STAFF RECOMMENDATION

2217 Lindell Avenue

May 19, 2021

Application: New Construction—Addition

Figures 2 & 3 show the existing curb cut and parking area.

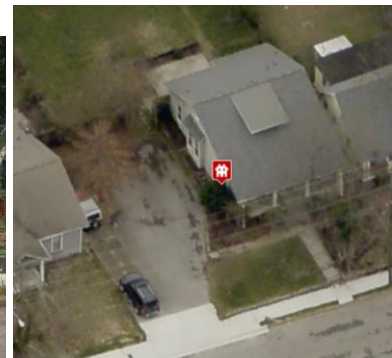
Orientation: There is an existing curb cut and front paving area to the left of the historic house (Figures 2 & 3). The paved area currently stops at the back corner of the historic house. The new side addition will truncate the driveway/paved area and make it even more like front yard parking than it is currently. Front yard parking is not an historic feature in the Woodland-in-Waverly neighborhood, and this lot has an alley for vehicular access to the site. Staff recommends that a condition of approval of the side addition be that the curb cut, driveway, and front parking area be removed and reclaimed as yard space.

With the condition that the curb cut, driveway, and front parking area be removed, staff finds that the addition meets Sections III.B.1. and III.B.2.f. of the design guidelines.

1 east elevation

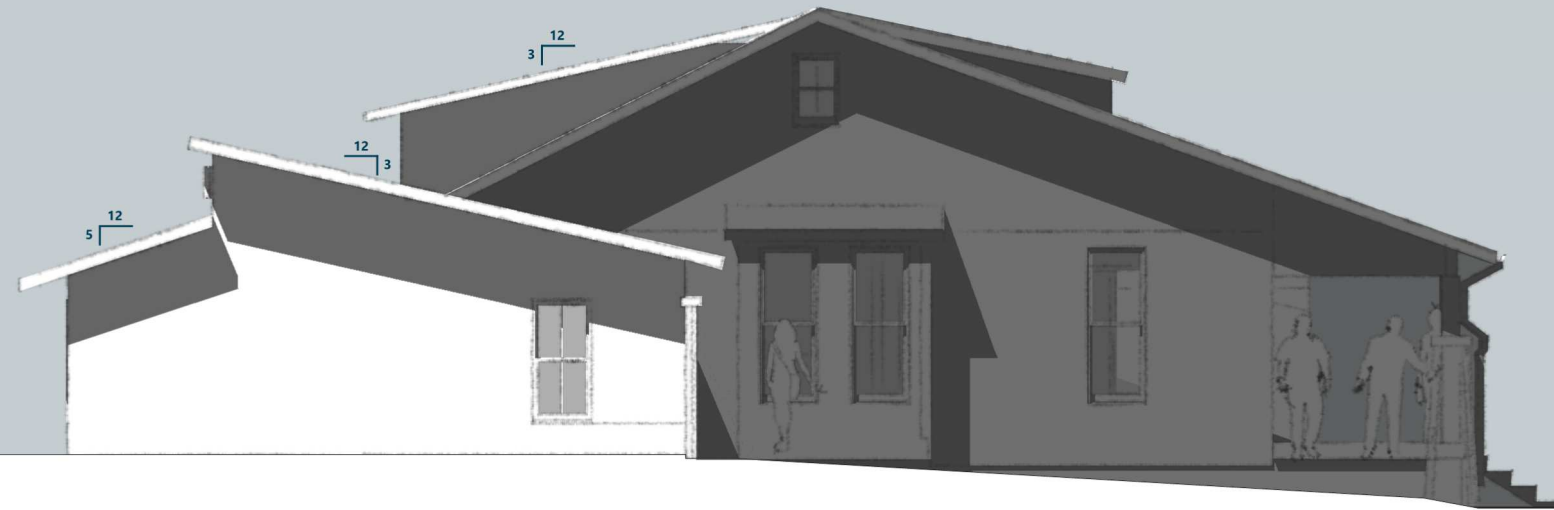
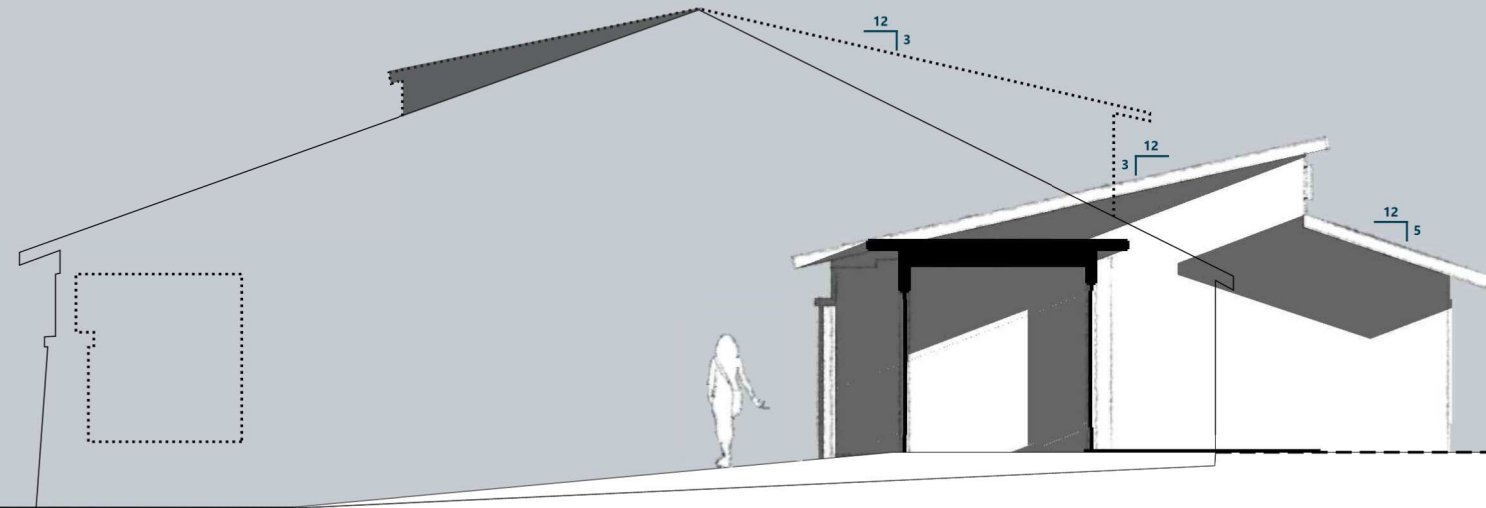
The hyphen will be largely glass doors and windows, which staff finds to be appropriate. The main portion of the addition will have a front façade that is largely a stone wall. Staff finds that this solid masonry wall is not appropriate for a street-facing façade and

recommends that the front façade of the side addition be a more appropriate material like lap siding or board and batten.

Proportion and Rhythm of Openings: No changes to the window and door openings on the existing house were indicated on the plans. The hyphen part of the addition will be almost entirely glass in the form of windows and doors. Staff finds this to be appropriate. The main portion of the side addition will have a ribbon of clerestory windows at the top of the addition. Staff finds that this window pattern is not typical of the historic district and does not meet the historic context. The fenestration pattern results in a large wall space without a window or door opening, which is not appropriate on a street-facing façade. Staff recommends that the fenestration pattern on the front-facing wall better reflect the pattern of the historic windows on the front façade of the house.

With the conditions that the front façade material be lap siding or board and batten and that staff approve all final material choices, staff finds that the materials meet Sections III.B.1. and III.B.2.d. of the design guidelines.

With the condition that the fenestration pattern on the front-facing wall better reflect the pattern of the historic windows on the front façade of the house, staff finds the project's proportion and rhythm of openings to meet Sections III.B.1. and III.B.2.g. of the design guidelines.
